TS-SSC 91-063
4/12/91

Subject: Evaluation of collar lamination inspection report (SSC 50 mm collar lamination without shims, part# ME-292059 rev. C)

Figure 1

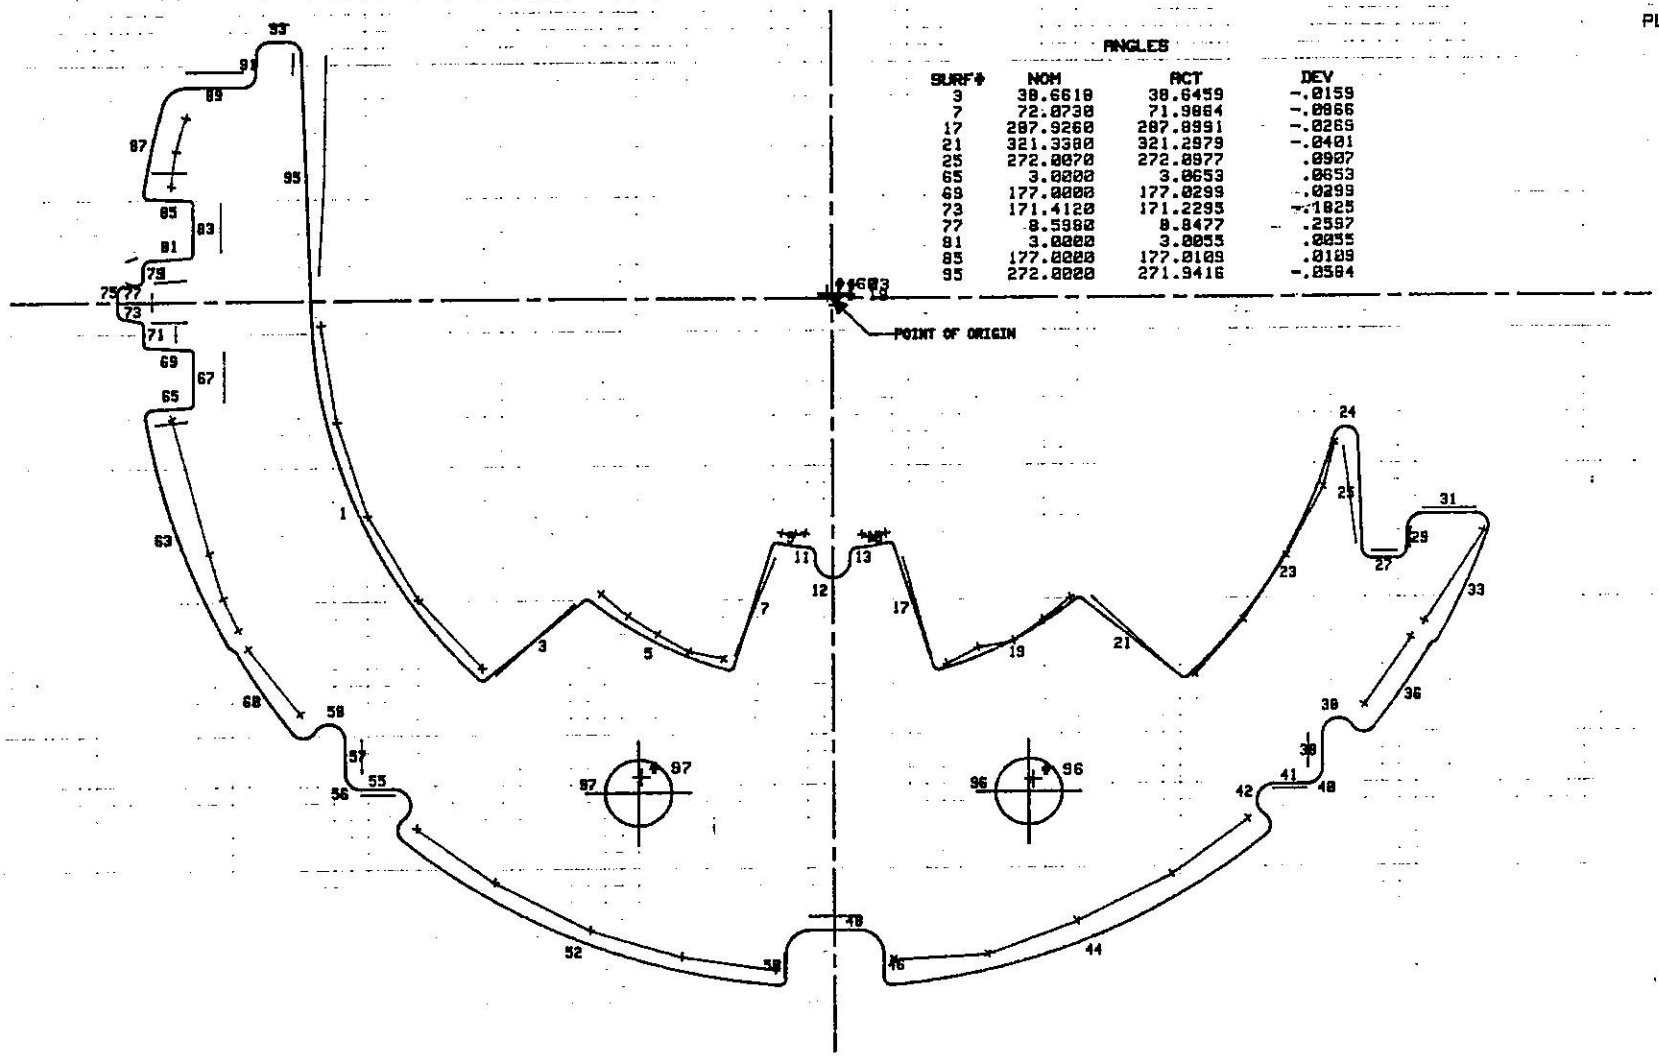
Figure 1 shows the optical contour projector inspection report for the revision C collars. The measured points for the collar interior match the design within a few tenths of a mil except along the long arm on the left which appears to be sprung inwards by about a mil at its tip. Since the slot into which this arm mates is very close to its design size and location, the sprung arm will tend to be forced to its design position, making the entire interior surface good to better than 0.5 mil. The active key surfaces (69 and 85) are translated up by a little over a mil. Thus the collar cavities, both for the inner and the outer coils, will be about 1 mil (per quadrant) larger than the design.

The "vertical" collar outer surface (33, 44, 52, 60) are shifted up by 1 mil. This shift is comparable to the shift in the key slots, so the undeflected collar diameters along these surfaces should be equal to the design within about a mil.

The fit between the collars and the tooling is set by the relation between the collar outer surface (principally surfaces 44 and 52) and the alignment flats (40 and 56). In a coordinate system set by surfaces 44 and 56, the alignment flats are shifted down by 1.5 mils, very close to the promised 2 mils. Because the "vertical" outer surface and the active key slot surfaces are both shifted up, the relationship between the two, which determines the amount of collaring tooling closure required for key insertion, is within a mil of the design.

The "horizontal" collar outer surfaces (33, 63 and 87) are designed to have an interference fit with the yoke. These are shifted inwards by about 1-1.5 mils. If the long arm on the left is moved closer to its design position under assembly, the "horizontal" outer surfaces are within a mil, although still shifted inwards, of the design. A modest inward shift is, in fact, desirable. The collar was designed[1] based on calculations[2] that indicated that the collar horizontal radius would decrease by about 0.5 mil under coil prestress. Experimentally the horizontal radius actually increases by 1-1.5 mils under prestress resulting in a horizontal yoke-collar interference up to 2 mils larger than called for in the design.

- In the first paragraph of "Evaluation of Rev. C Collar," how do you deduce the 0.5 mil?
- In the last paragraph of the same section you metion that "experimetnally the horizontal radius actually increases under prestress." This probably refers to the last collar deflection measurements you made. Could you fax or mail me your data?
- In the second paragraph of "Comparison with Revision A" you refer to the vertical outer surface. Do you mean the "design" surface or the "actual" one.
- At the end of the same paragraph, we cannot make out the 4.5 mils number you give.

As shown on the inspection report the only part of the collar interior that deviates from the design by more than 0.5 mil is the vertical surface of the long arm on the left above the center line. Since this part of the collar does not contact the coil it is less important than the rest. Note, however, that the slot on the right into which the tab at the end of the long arm fits is, at it bottom, of the design width and position within a few tenths of a mil. Since the short piece on the right is much stiffer than the long arm on the left, when the two are mated it is the long arm that will deflect the match the short one. This will move the arm to the left forcing it to within 0.5 mil of the desig location.

Figure 2

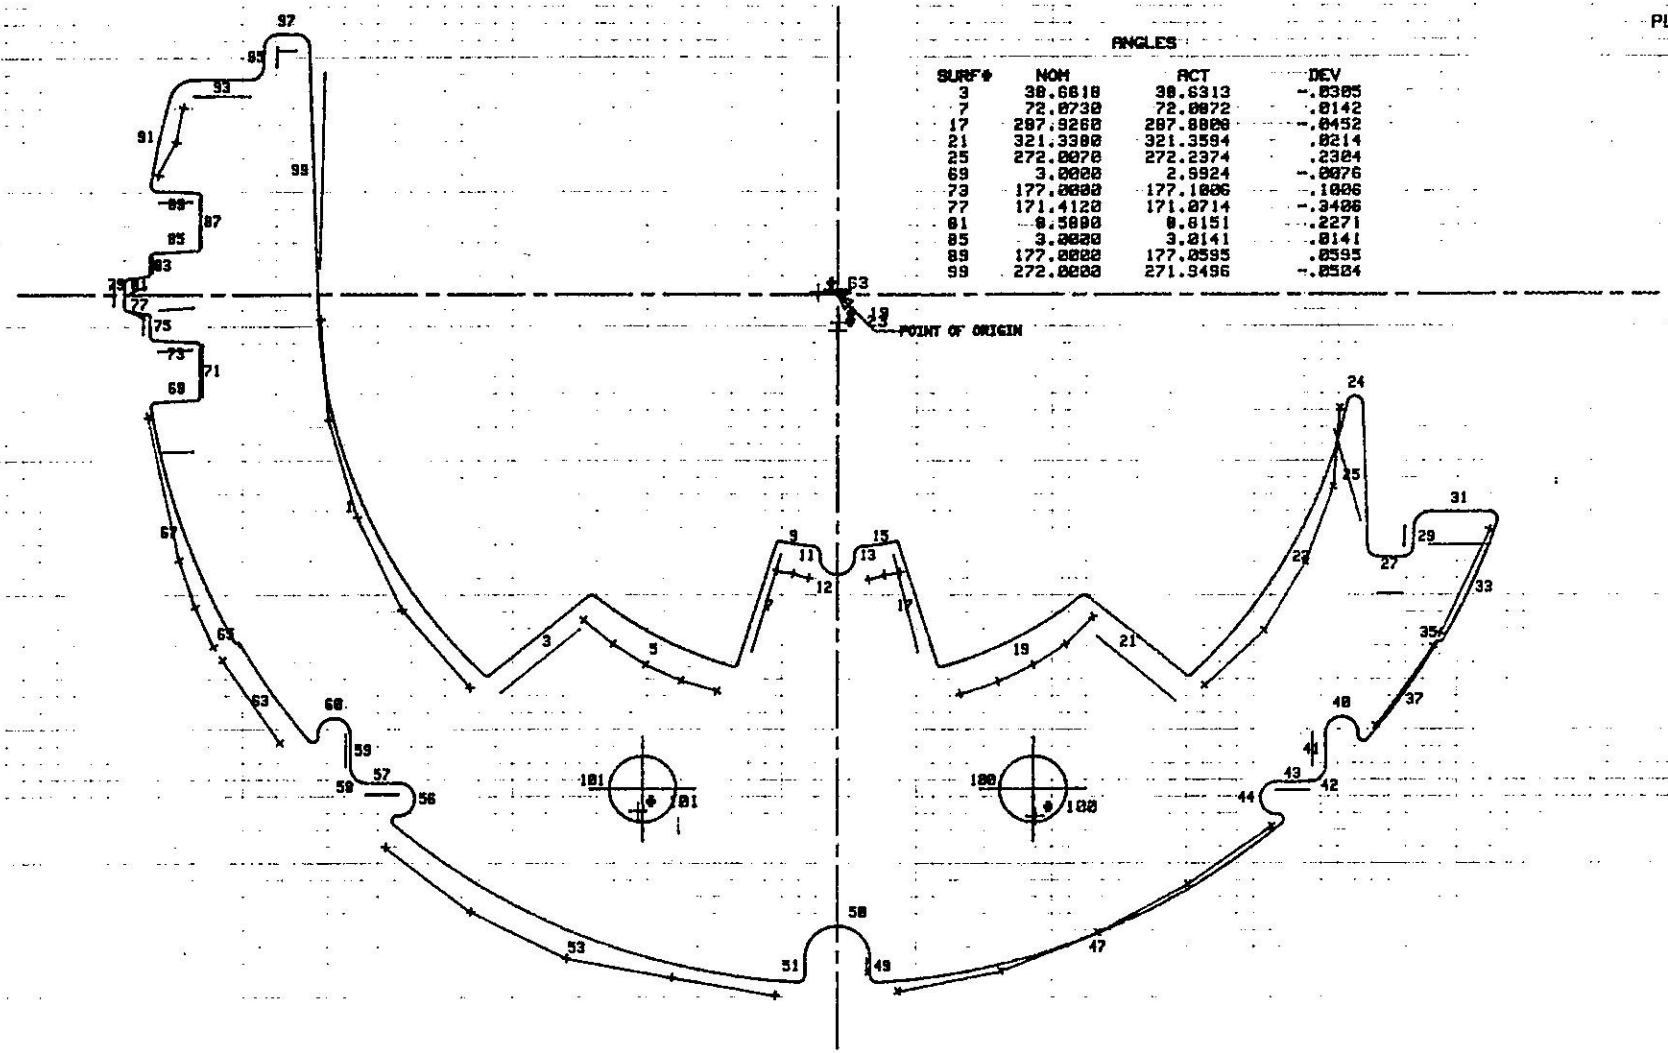
Figure 2 shows the optical contour projector inspection report for the revision A collars. The active key surfaces (73 and 89) are shifted down by about 0.5 mil and the entire collar interior (1, 3, 5, 7, 17, 19 21 and 23) is shifted down by 1.5-2 mils. In a coordinate system normalized vertically to put the key surfaces at the design position (these are the coordinates that describe the collars after they are keyed) the collar interior is shifted down by an average of a bit over a mil. Therefore the coil cavities are a little over a mil larger than the design size. The difference between the coil cavities of the revision C and revision A collars is less than a mil and is probably zero within the measurement accuracy.

Normalized to the "vertical" outer surface (47 and 53) the active key surfaces are within a few tenths of a mil of the design. This is the same within the probable measurement accuracy as for the revision C collars. Thus the revision C collars will require about the same compression for key insertion as used for the revision A collars. Normalized to the "vertical" outer surface the alignment flats are within a few tenths of a mil of the design. Relative to revision A, therefore, the revision C collar flats are about 4.5 mils closer to the tooling which will eliminate the current need for 5 mil shims on these surfaces.

On the revision A collar the "horizontal" outer surfaces (33, 67 and 91) are radially shifted relative to the design by from -1 mil (surface 91) to +1 mil (surface 67). On the average these surfaces on the revision C collar are at a radius 0-1 mil smaller than on the revision A collars. This is desirable, as noted above, since it will result in a fit between the collared coil and the yoke that is closer to the design.

- In the second paragraph of "Comparison with Revision A" you refer to the vertical outer surface. Do you mean the "design" surface or the "actual" one.

- At the end of the same paragraph, we cannot make out the 4.5 mils number you give.

"Normalized to the 'vertical' outer suface" means that all the measured points are moved upwards until, on the average, the measured points on the "vertical" outer surface lie on top of the design. Then the comparison between measured and design locations of the the key slots and alignment flats is made.

Between Revision A and Revision C the design location of the alignment flats was moved down by 3 mils. In the Revision A collars the flats, relative to the "vertical" outer surface, are at their design location with measurement error. In the Revision C collars the flats, relative to the "vertical" outer surface, are down by 1.5 mils from the design location. Thus the net change in the position of the flats relative

to the "vertical" outer surface is 3 + 1.5 = 4.5 mils.

Figure 3

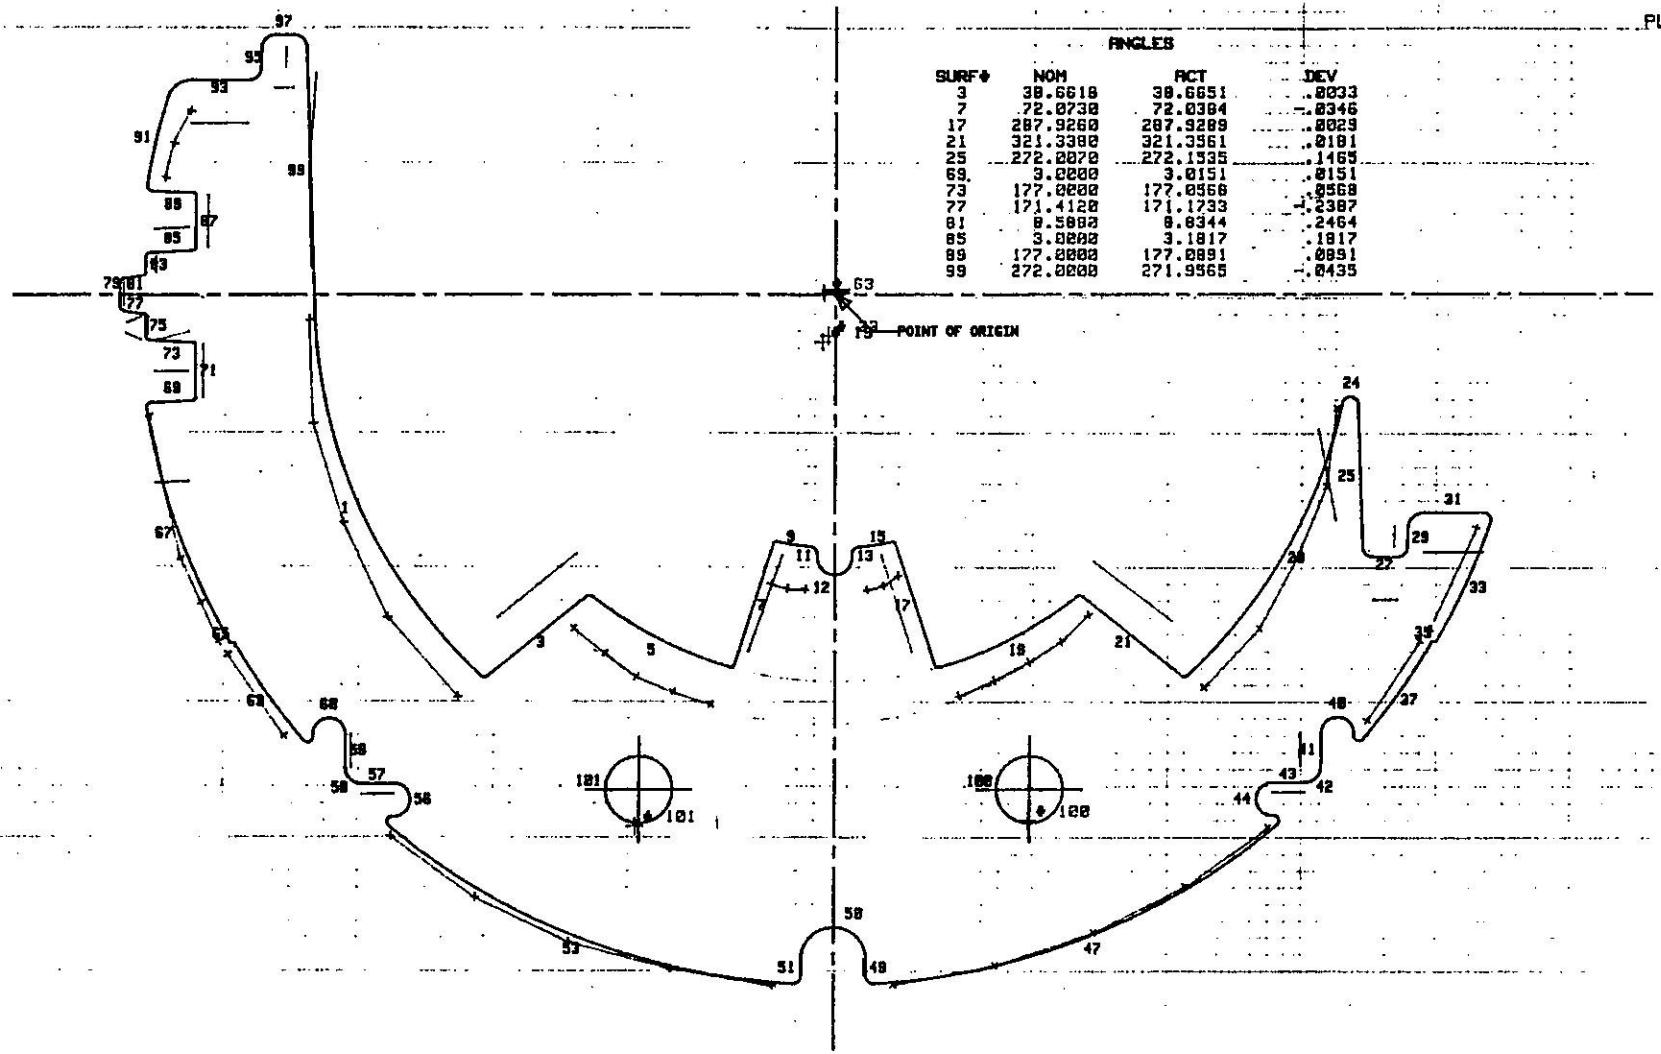
It should be noted that the initial inspection of the revision A collars was made with respect to an incorrect version of the revision A drawing, which had the outer coil pole surfaces shifted by 5 mils away from the mid-plane in a direction perpendicular to the pole surface relative to the correct drawing. According to Steve Merkler this error was corrected on 10/4/90. Any inspections done before this are incorrect and the corresponding reports should be discarded. An example incorrect inspection report is attached as Figure 3.
